COUNCIL ASSESSMENT REPORT

Panel Reference	2017SNH019
DA Number	N0341/15/S96/1
LGA	Northern Beaches Council
Proposed Development	Section 96(2) Application to modify the private hospital approved pursuant to N0341/15
Street Address	4 Daydream Street, Warriewood
Applicant/Owner	Strata Plan 80638 and Breckenridge Funds Management Limited C/ Buildcorp Pty Ltd
Date of DA lodgement	22 February 2017
Number of Submissions	2
Recommendation	Modify Consent
Regional Development Criteria	S96(2) modification application to development previously approved by JRPP
List of all relevant s79C(1)(a) matters	<ul style="list-style-type: none"> • Environmental Planning and Assessment Act 1979 • Environmental Planning and Assessment Regulation 2000 • State Environmental Planning Policy No.64 – Advertising and Signage • State Environmental Planning Policy (Infrastructure) 2007 • Pittwater Local Environmental Plan 2014 • Pittwater 21 Development Control Plan

N0341/15/S96/1 – 4 Daydream Street, Warriewood (Lot 39 SP 80638)

Section 96(2) Application to modify the private hospital approved pursuant to N0341/15

Figure 2 – Roof plan with approved heights (in black text) and proposed heights (in red text)

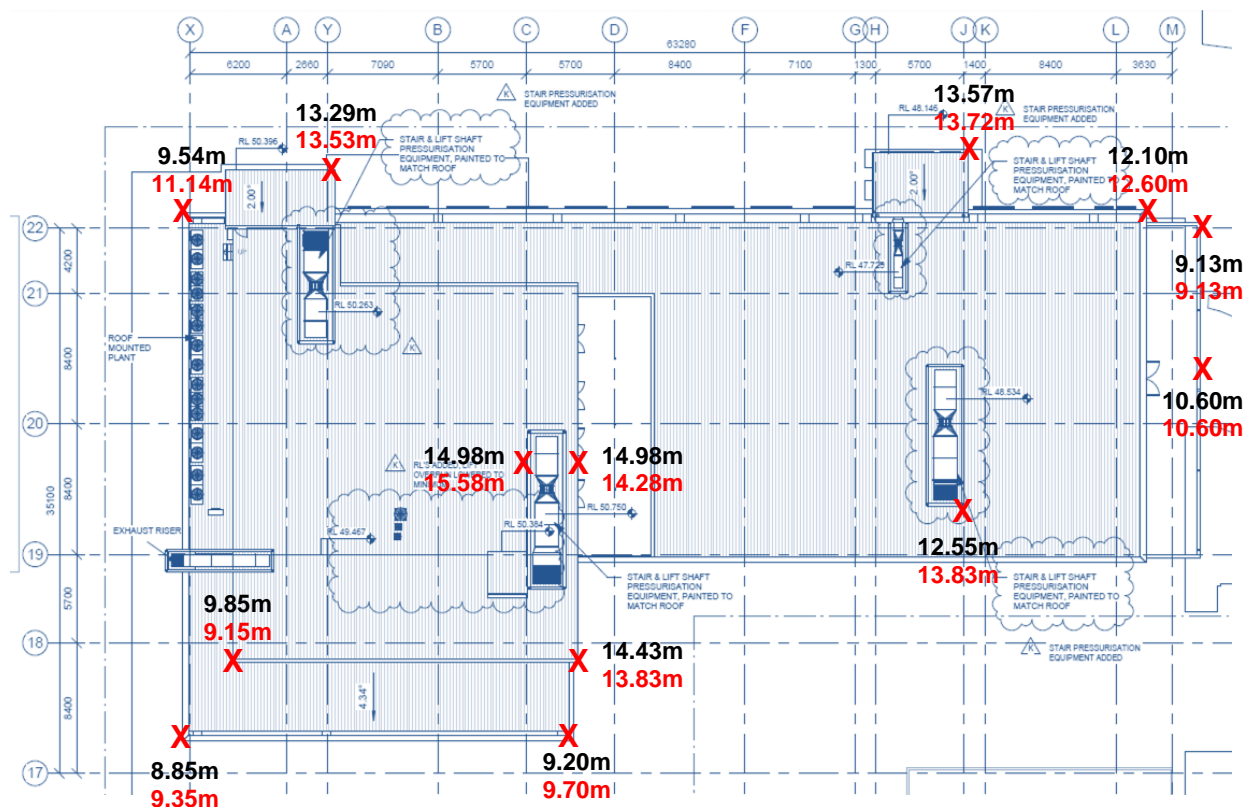
The primary changes to the height of the development are as follows:

- The parapet around the Level 4 roof is proposed to be increased by 500mm, resulting in an overall height of 1.7m. Despite the production of an amended statement addressing the proposed changes to the building height, no justification is provided for this change. The increase to the parapet height attributes to unnecessary and excessive bulk atop the proposed building, inconsistent with the objectives that aim to minimise the visual impact of the development.

- With the exception of the south-western corner of the Level 4 roof, the entire span of the Level 4 roof parapet is above the 11m height limit, with a maximum protrusion of 1.6m occurring in the north-eastern corner of the building fronting Daydream Street. There has been no justification provided by the applicant in this regard, and the change is incorrectly identified as a “minor decrease in roof parapet height” in the schedule of changes provided and is not nominated as a change on the amended architectural drawings provided. The proposed increase to the height of the parapet is an unreasonable breach of the building height development standard and is not supported.

- The height of the Level 5 roof was increased during the assessment of the original development application to ensure that all plant equipment and the lift over run was enclosed within the roof form. The Level 5 roof is now proposed to be lowered, and whilst an exposed lift overrun is shown on the plans, the applicant’s planning consultant has since confirmed that this change is not sought by the subject application. The lowering of the roof is supported subject to a condition requiring the plans to be amended to delete the lift overrun.

- The SOEE has identified that the newly produced air pressurisation equipment is a BCA requirement to ensure that in the event of a fire, smoke is removed from the emergency exit stairwells. The systems extend up to 1.8m above the associated roof, and are proposed to be enclosed by what appears to be louvered screens. Despite being identified in the BCA report that was provided at the time of lodgement, the applicant did not address the systems in the clause 4.6 submission provided, gave assurances that plant equipment could internally integrated into the design of the development, and accepted conditions to restrict plant equipment from the roof. Whilst the systems and the associated screens result in a less than ideal architectural response, the need for the systems is acknowledged and conditions are recommended to ensure the use of dark and non-reflective finishes.

- The height of parapet around the Level 4 roof shall not exceed RL 47050.
- The overrun of Lift 01 must not extend above the Level 5 roof plane.
- The stair & lift pressurisation equipment and associated screens shall be non-reflective and painted/finished in the same colour as the roof.
- The screen shown in white along the western façade of the Level 4 roof is not authorised by this consent.
